From: Planning
Sent: 23 July 2026 15:46
Subject: FW: DISC/26/0153 - Greenway Academy
Attachments: DISC 26 0153 - Greenway Academy.pdf; SRP1029-LLB-00-EX-D-O-2005.pdf

TO:	Horsham District Council – Planning Dept
LOCATION:	Greenway Academy Greenway Horsham West Sussex
DESCRIPTION:	Application for Approval of Details Reserved by Condition 3, 4, 5 and 6 to approved application DC/22/1954
REFERENCE:	DISC/26/0153
RECOMMENDATION:	Condition 3: More information Condition 4: More information Condition 5: Modification Condition 6: No comments

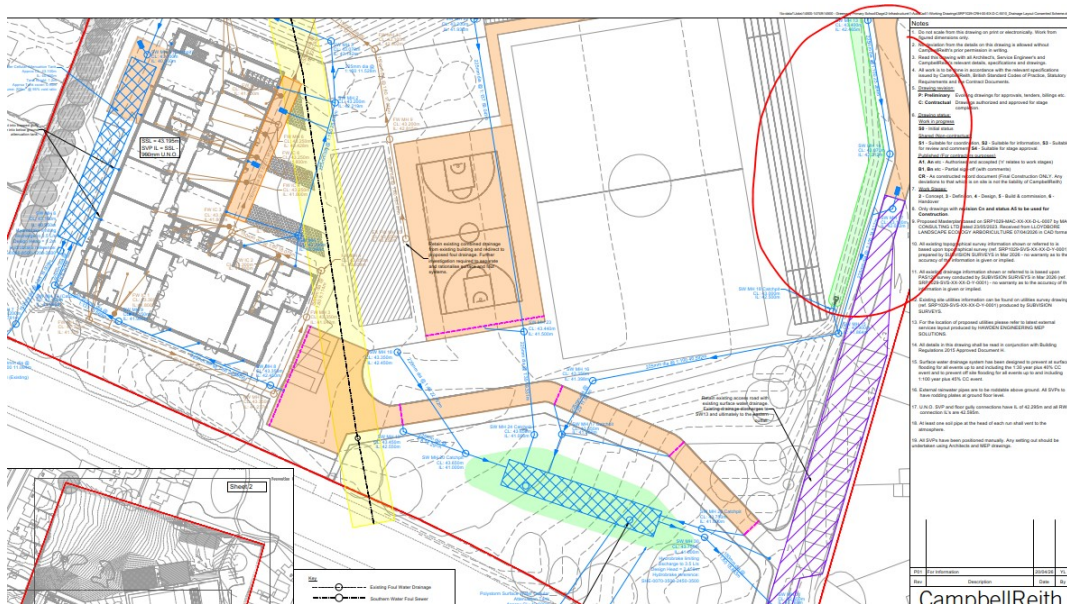
Condition 3: Reference to a swale system is noted within the technical note, however, appears absent from proposals. Clarification and location is requested; it is queried if the proposed detention basin – previously labelled as a swale – is what is meant by 'swale system'.

The swale referred to in the tech note is the swale adjacent to the access road as shown on the below screenshot. An attenuation basin is proposed further south, as shown below. Importantly, the LLFA are satisfied with the proposals as dated in their response 16 June.

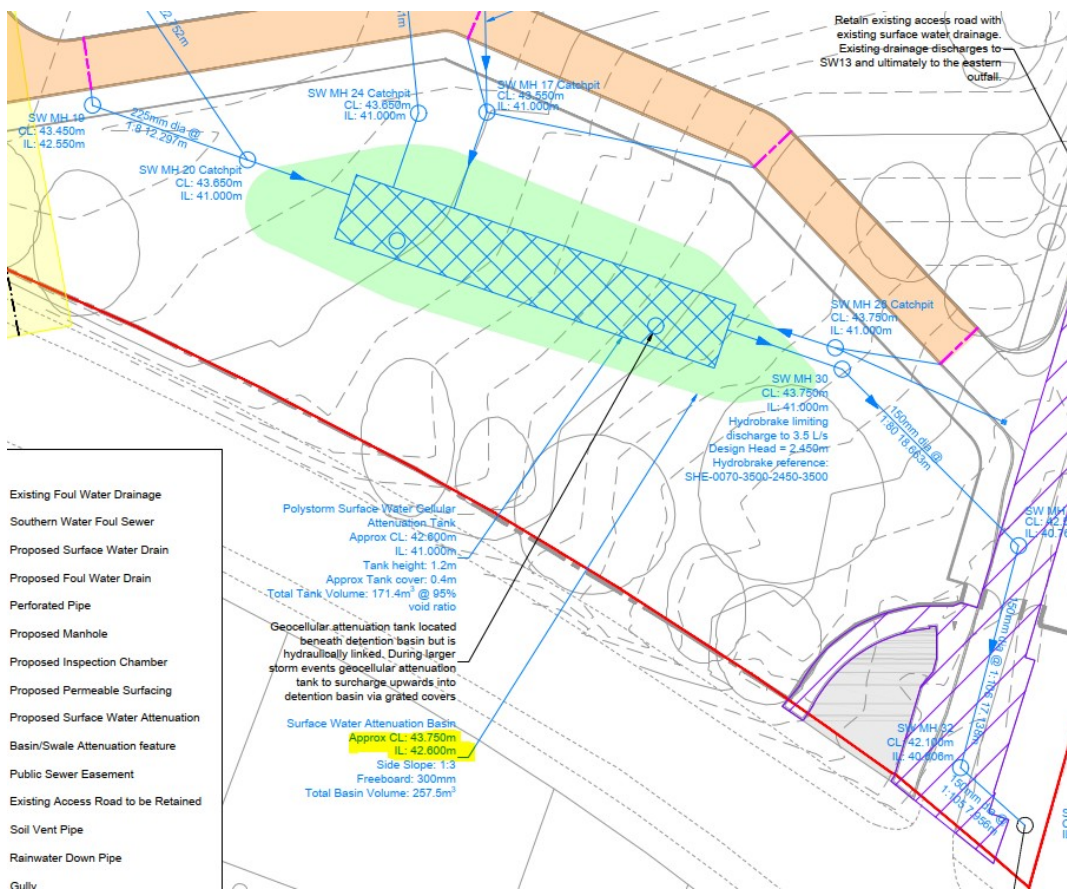
Condition 4: Required ground excavations have not been provided. Given the proposed detention basin in proximity to existing trees, this is necessary to ensure that earthworks are not proposed within RPAs. Trees are highly susceptible to rapid decline due to sudden changes in their rooting medium, such as changes to hydrology, increased water levels or mounding, thus the layout should demonstrate avoidance.

The depth of the basin is shown on the drawings, as highlighted in the screenshot below. The maximum depth of the basin is 1.15m, with a side slope of 1:3. We have also overlaid the basin onto the RPA drawing, attached, for further clarity. The green area shown in the image below indicates the full construction area, including the banks and bunds. As shown on the attached drawing, the proposed falls sit outside all RPAs.

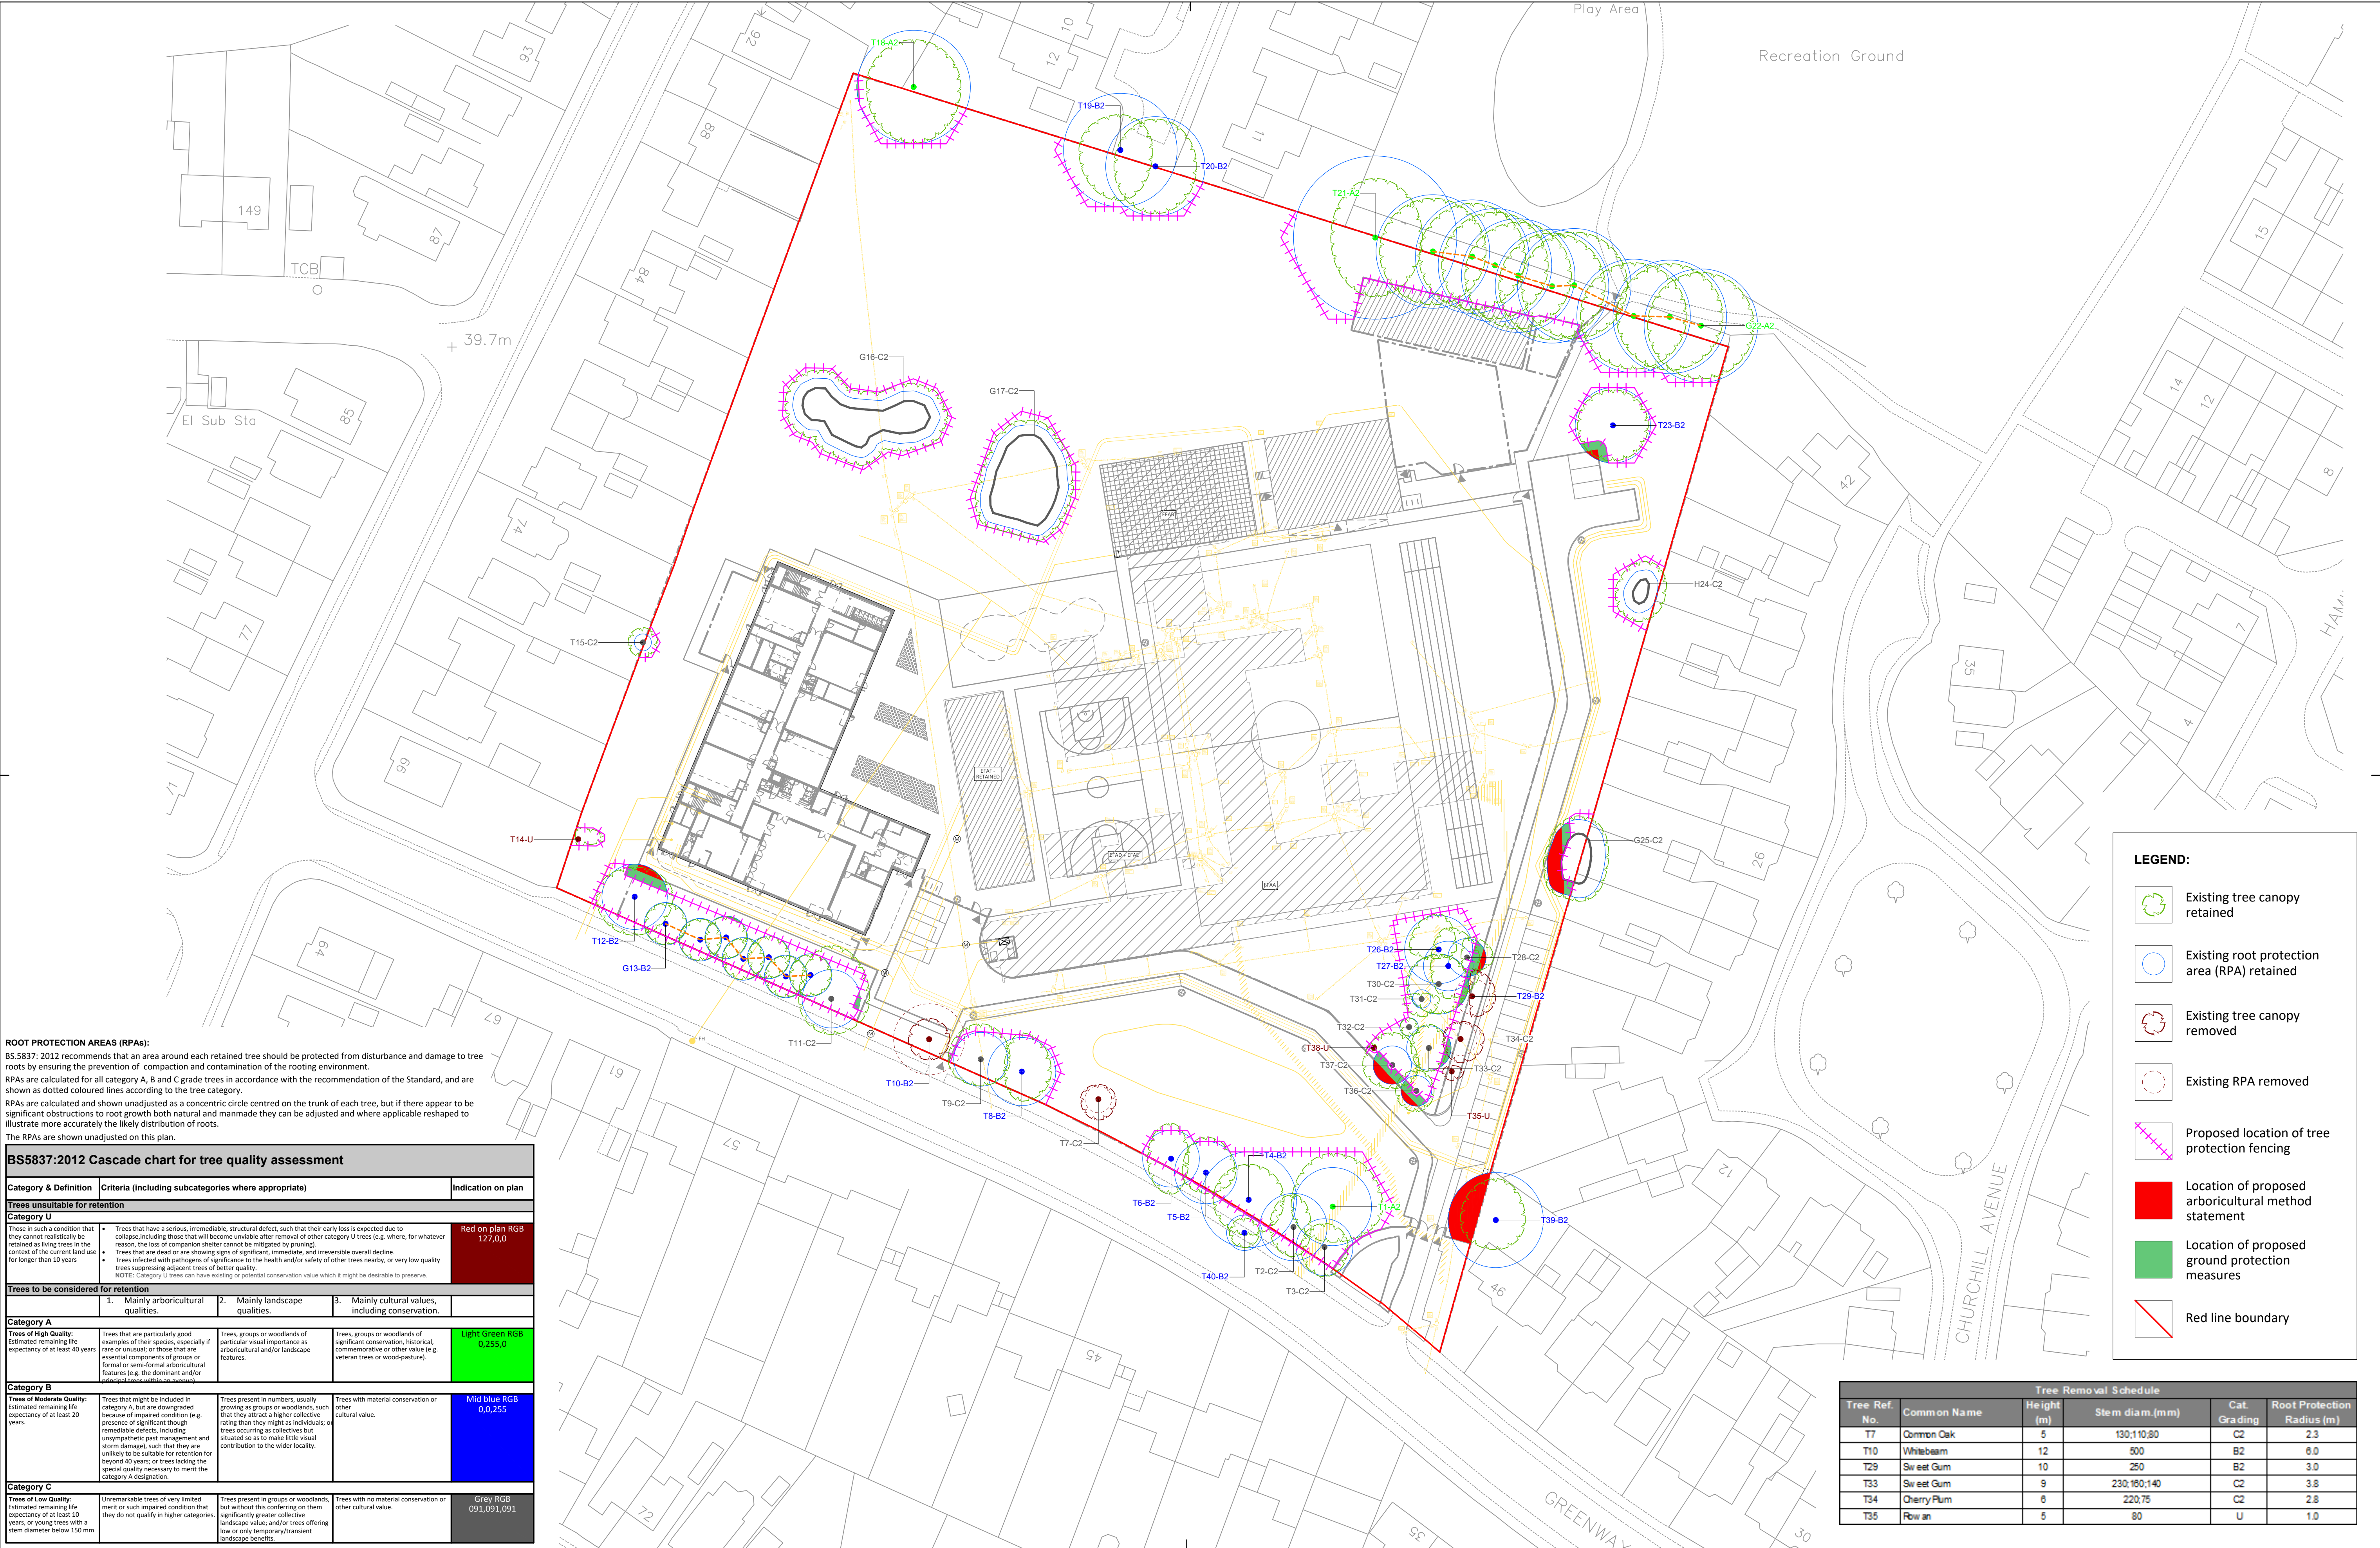
Condition 5: Some discrepancy is noted within the documentation provided. For example, the existing gas is proposed to be stripped out prior to demolition of the existing building, however this is not reflected in the tree

protection fencing (TPF) layout. The stripping of this utility run is recommended against given its placement within mature tree groups and particularly Cat A T1. Please explore if it can be decommissioned and left in situ instead. If it cannot, the description of sensitive methods to limit harm to the trees is requested, noting that TPF may need amending accordingly.

It is noted that TPF is proposed within the tree groups, below, either side of the existing drainage run. These runs are not proposed to be removed, thus the TPF should be amended accordingly.

T9 is included within the tree removal schedule but appears to be retained in plan. No development appears to be proposed within its RPA; thus, its retention is requested in order to limit erosion of the well treed townscape character and in order to provide benefits to visual amenity in screening proposed built form and massing. Please amend the schedule accordingly.

The project team has reviewed the retained services and proposed works in relation to retained trees and RPAs. The updated Tree Removal, Protection & Retention Plan, identifies the retained trees, retained RPAs, proposed tree protection fencing, arboricultural method statement areas and ground protection measures.

In response to the concern regarding the existing gas service, the contractor has confirmed that the gas pipework can be fully purged/decommissioned and left in situ. As such, no excavation or stripping out of the gas service within the RPAs is proposed, thereby avoiding potential impact to the mature tree groups and, in particular, Category A tree T1.

The existing drainage runs within/adjacent to the tree groups are also to be retained in situ and do not require excavation or removal. The tree protection fencing layout has therefore been reviewed on this basis.

In relation to the path works associated with G16 and G17, the contractor has confirmed that no excavation is required for these works. The relevant area will be protected by fencing for the majority of the construction phase, with only a short-term local adjustment to the fencing required to facilitate the path works towards the end of Phase 1. The fencing will otherwise remain as shown on the updated Tree Protection Plan, with works undertaken in accordance with the Arboricultural Method Statement.

The updated drawing also confirms that T9 is to be retained and has been removed from the Tree Removal Schedule, addressing the LPA's request for its retention.

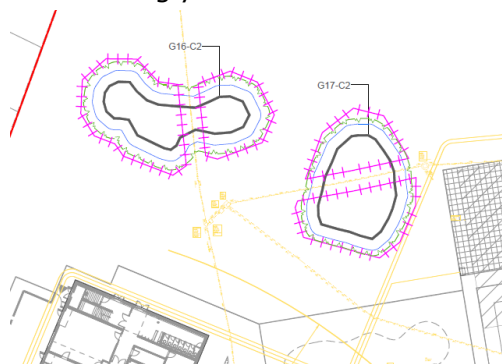
3. Some discrepancy is noted within the documentation provided. For example, the existing gas is proposed to be stripped out prior to demolition of the existing building, however this is not reflected in the tree protection fencing (TPF) layout. The stripping of this utility run is recommended against given its placement within mature tree groups and particularly Cat A T1. Please explore if it can be decommissioned and left in situ instead. If it cannot, the description of sensitive methods to limit harm to the trees is requested, noting that TPF may need amending accordingly.

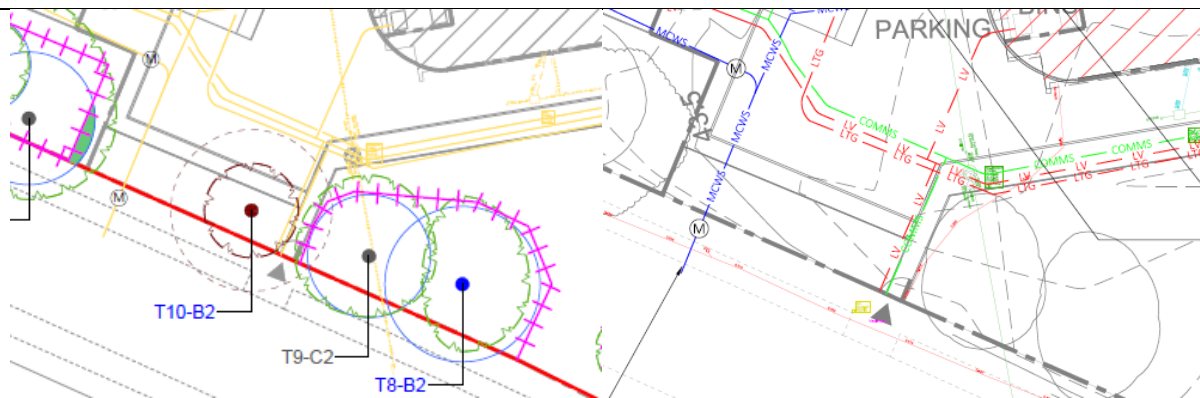
4. It is noted that TPF is proposed within the tree groups, below, either side of the existing drainage run. These runs are not proposed to be removed, thus the TPF should be amended accordingly.
